UNIT 3 & 4 WESLEY GATE, READING

Approved Document E Design Review

Report No. 17-0090-0 R01

Date: 14 September 2017

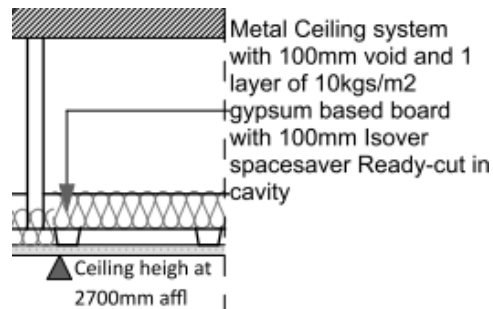
The current proposal presented on the Hives Architects' drawings (drawing no. 2684 018 P1) is to remove the raised floor (as it would normally be partially destroyed whilst breaking out areas to form the new demises' separating walls in any case), and replace with the following:

This would be expected to provide a similar level of airborne sound insulation and an improved level of impact sound reduction and would therefore be a reasonable proposal.

It is essential that the “Noggins at 2.5mm centres” donot bridge between floor slab and chipboard, with a gap below or formed from acoustic battens. It is also essential that the resilient edging strips are used and manufacturer’s instructions followed.

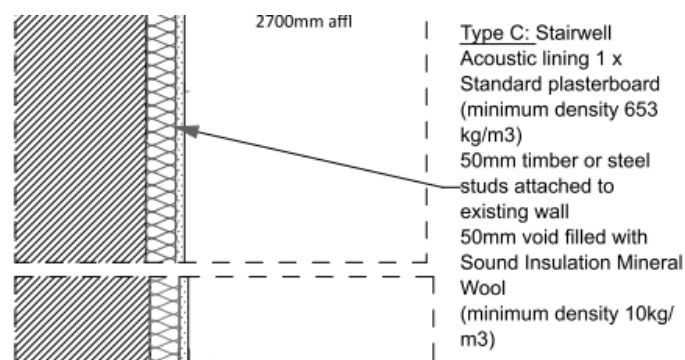
The construction works will remove the existing false ceiling system and it is proposed to replace with the following:

This is considered reasonable, however it is recommended the ceiling void should be at least 100mm and avoid having a similar depth to the floor void (i.e. if the raised access floor is 130mm, the ceiling void should be at least 150mm). The deeper the void the better the performance tends to be at lower frequencies.

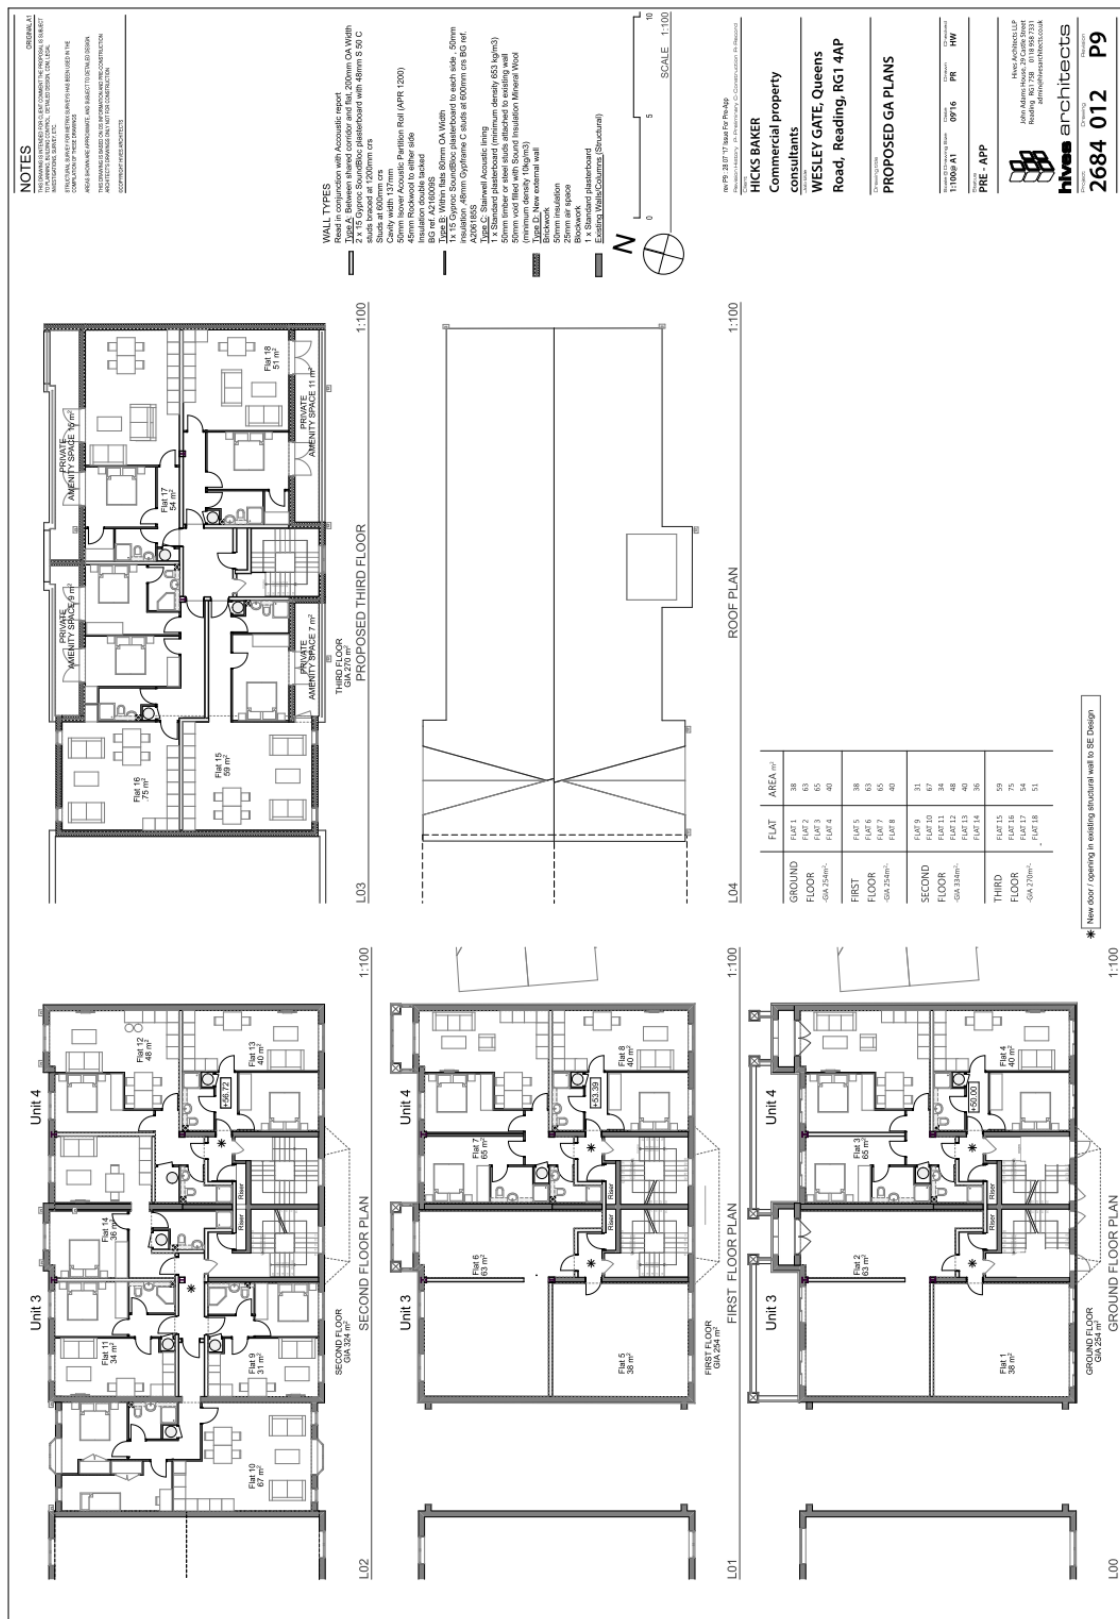
In lightweight drylined walls, especially when used to form separating walls between demises, inclusion of electrical sockets / switches can reduce the airborne sound insulation performance.

Therefore, sockets in separating walls should not be back to back and it is advised to provide back-box enclosures (of similar combined mass to the separating wall linings) around all electrical sockets / switches in the demises separating walls. Alternatively, proprietary sound deadening putty pads could be used.
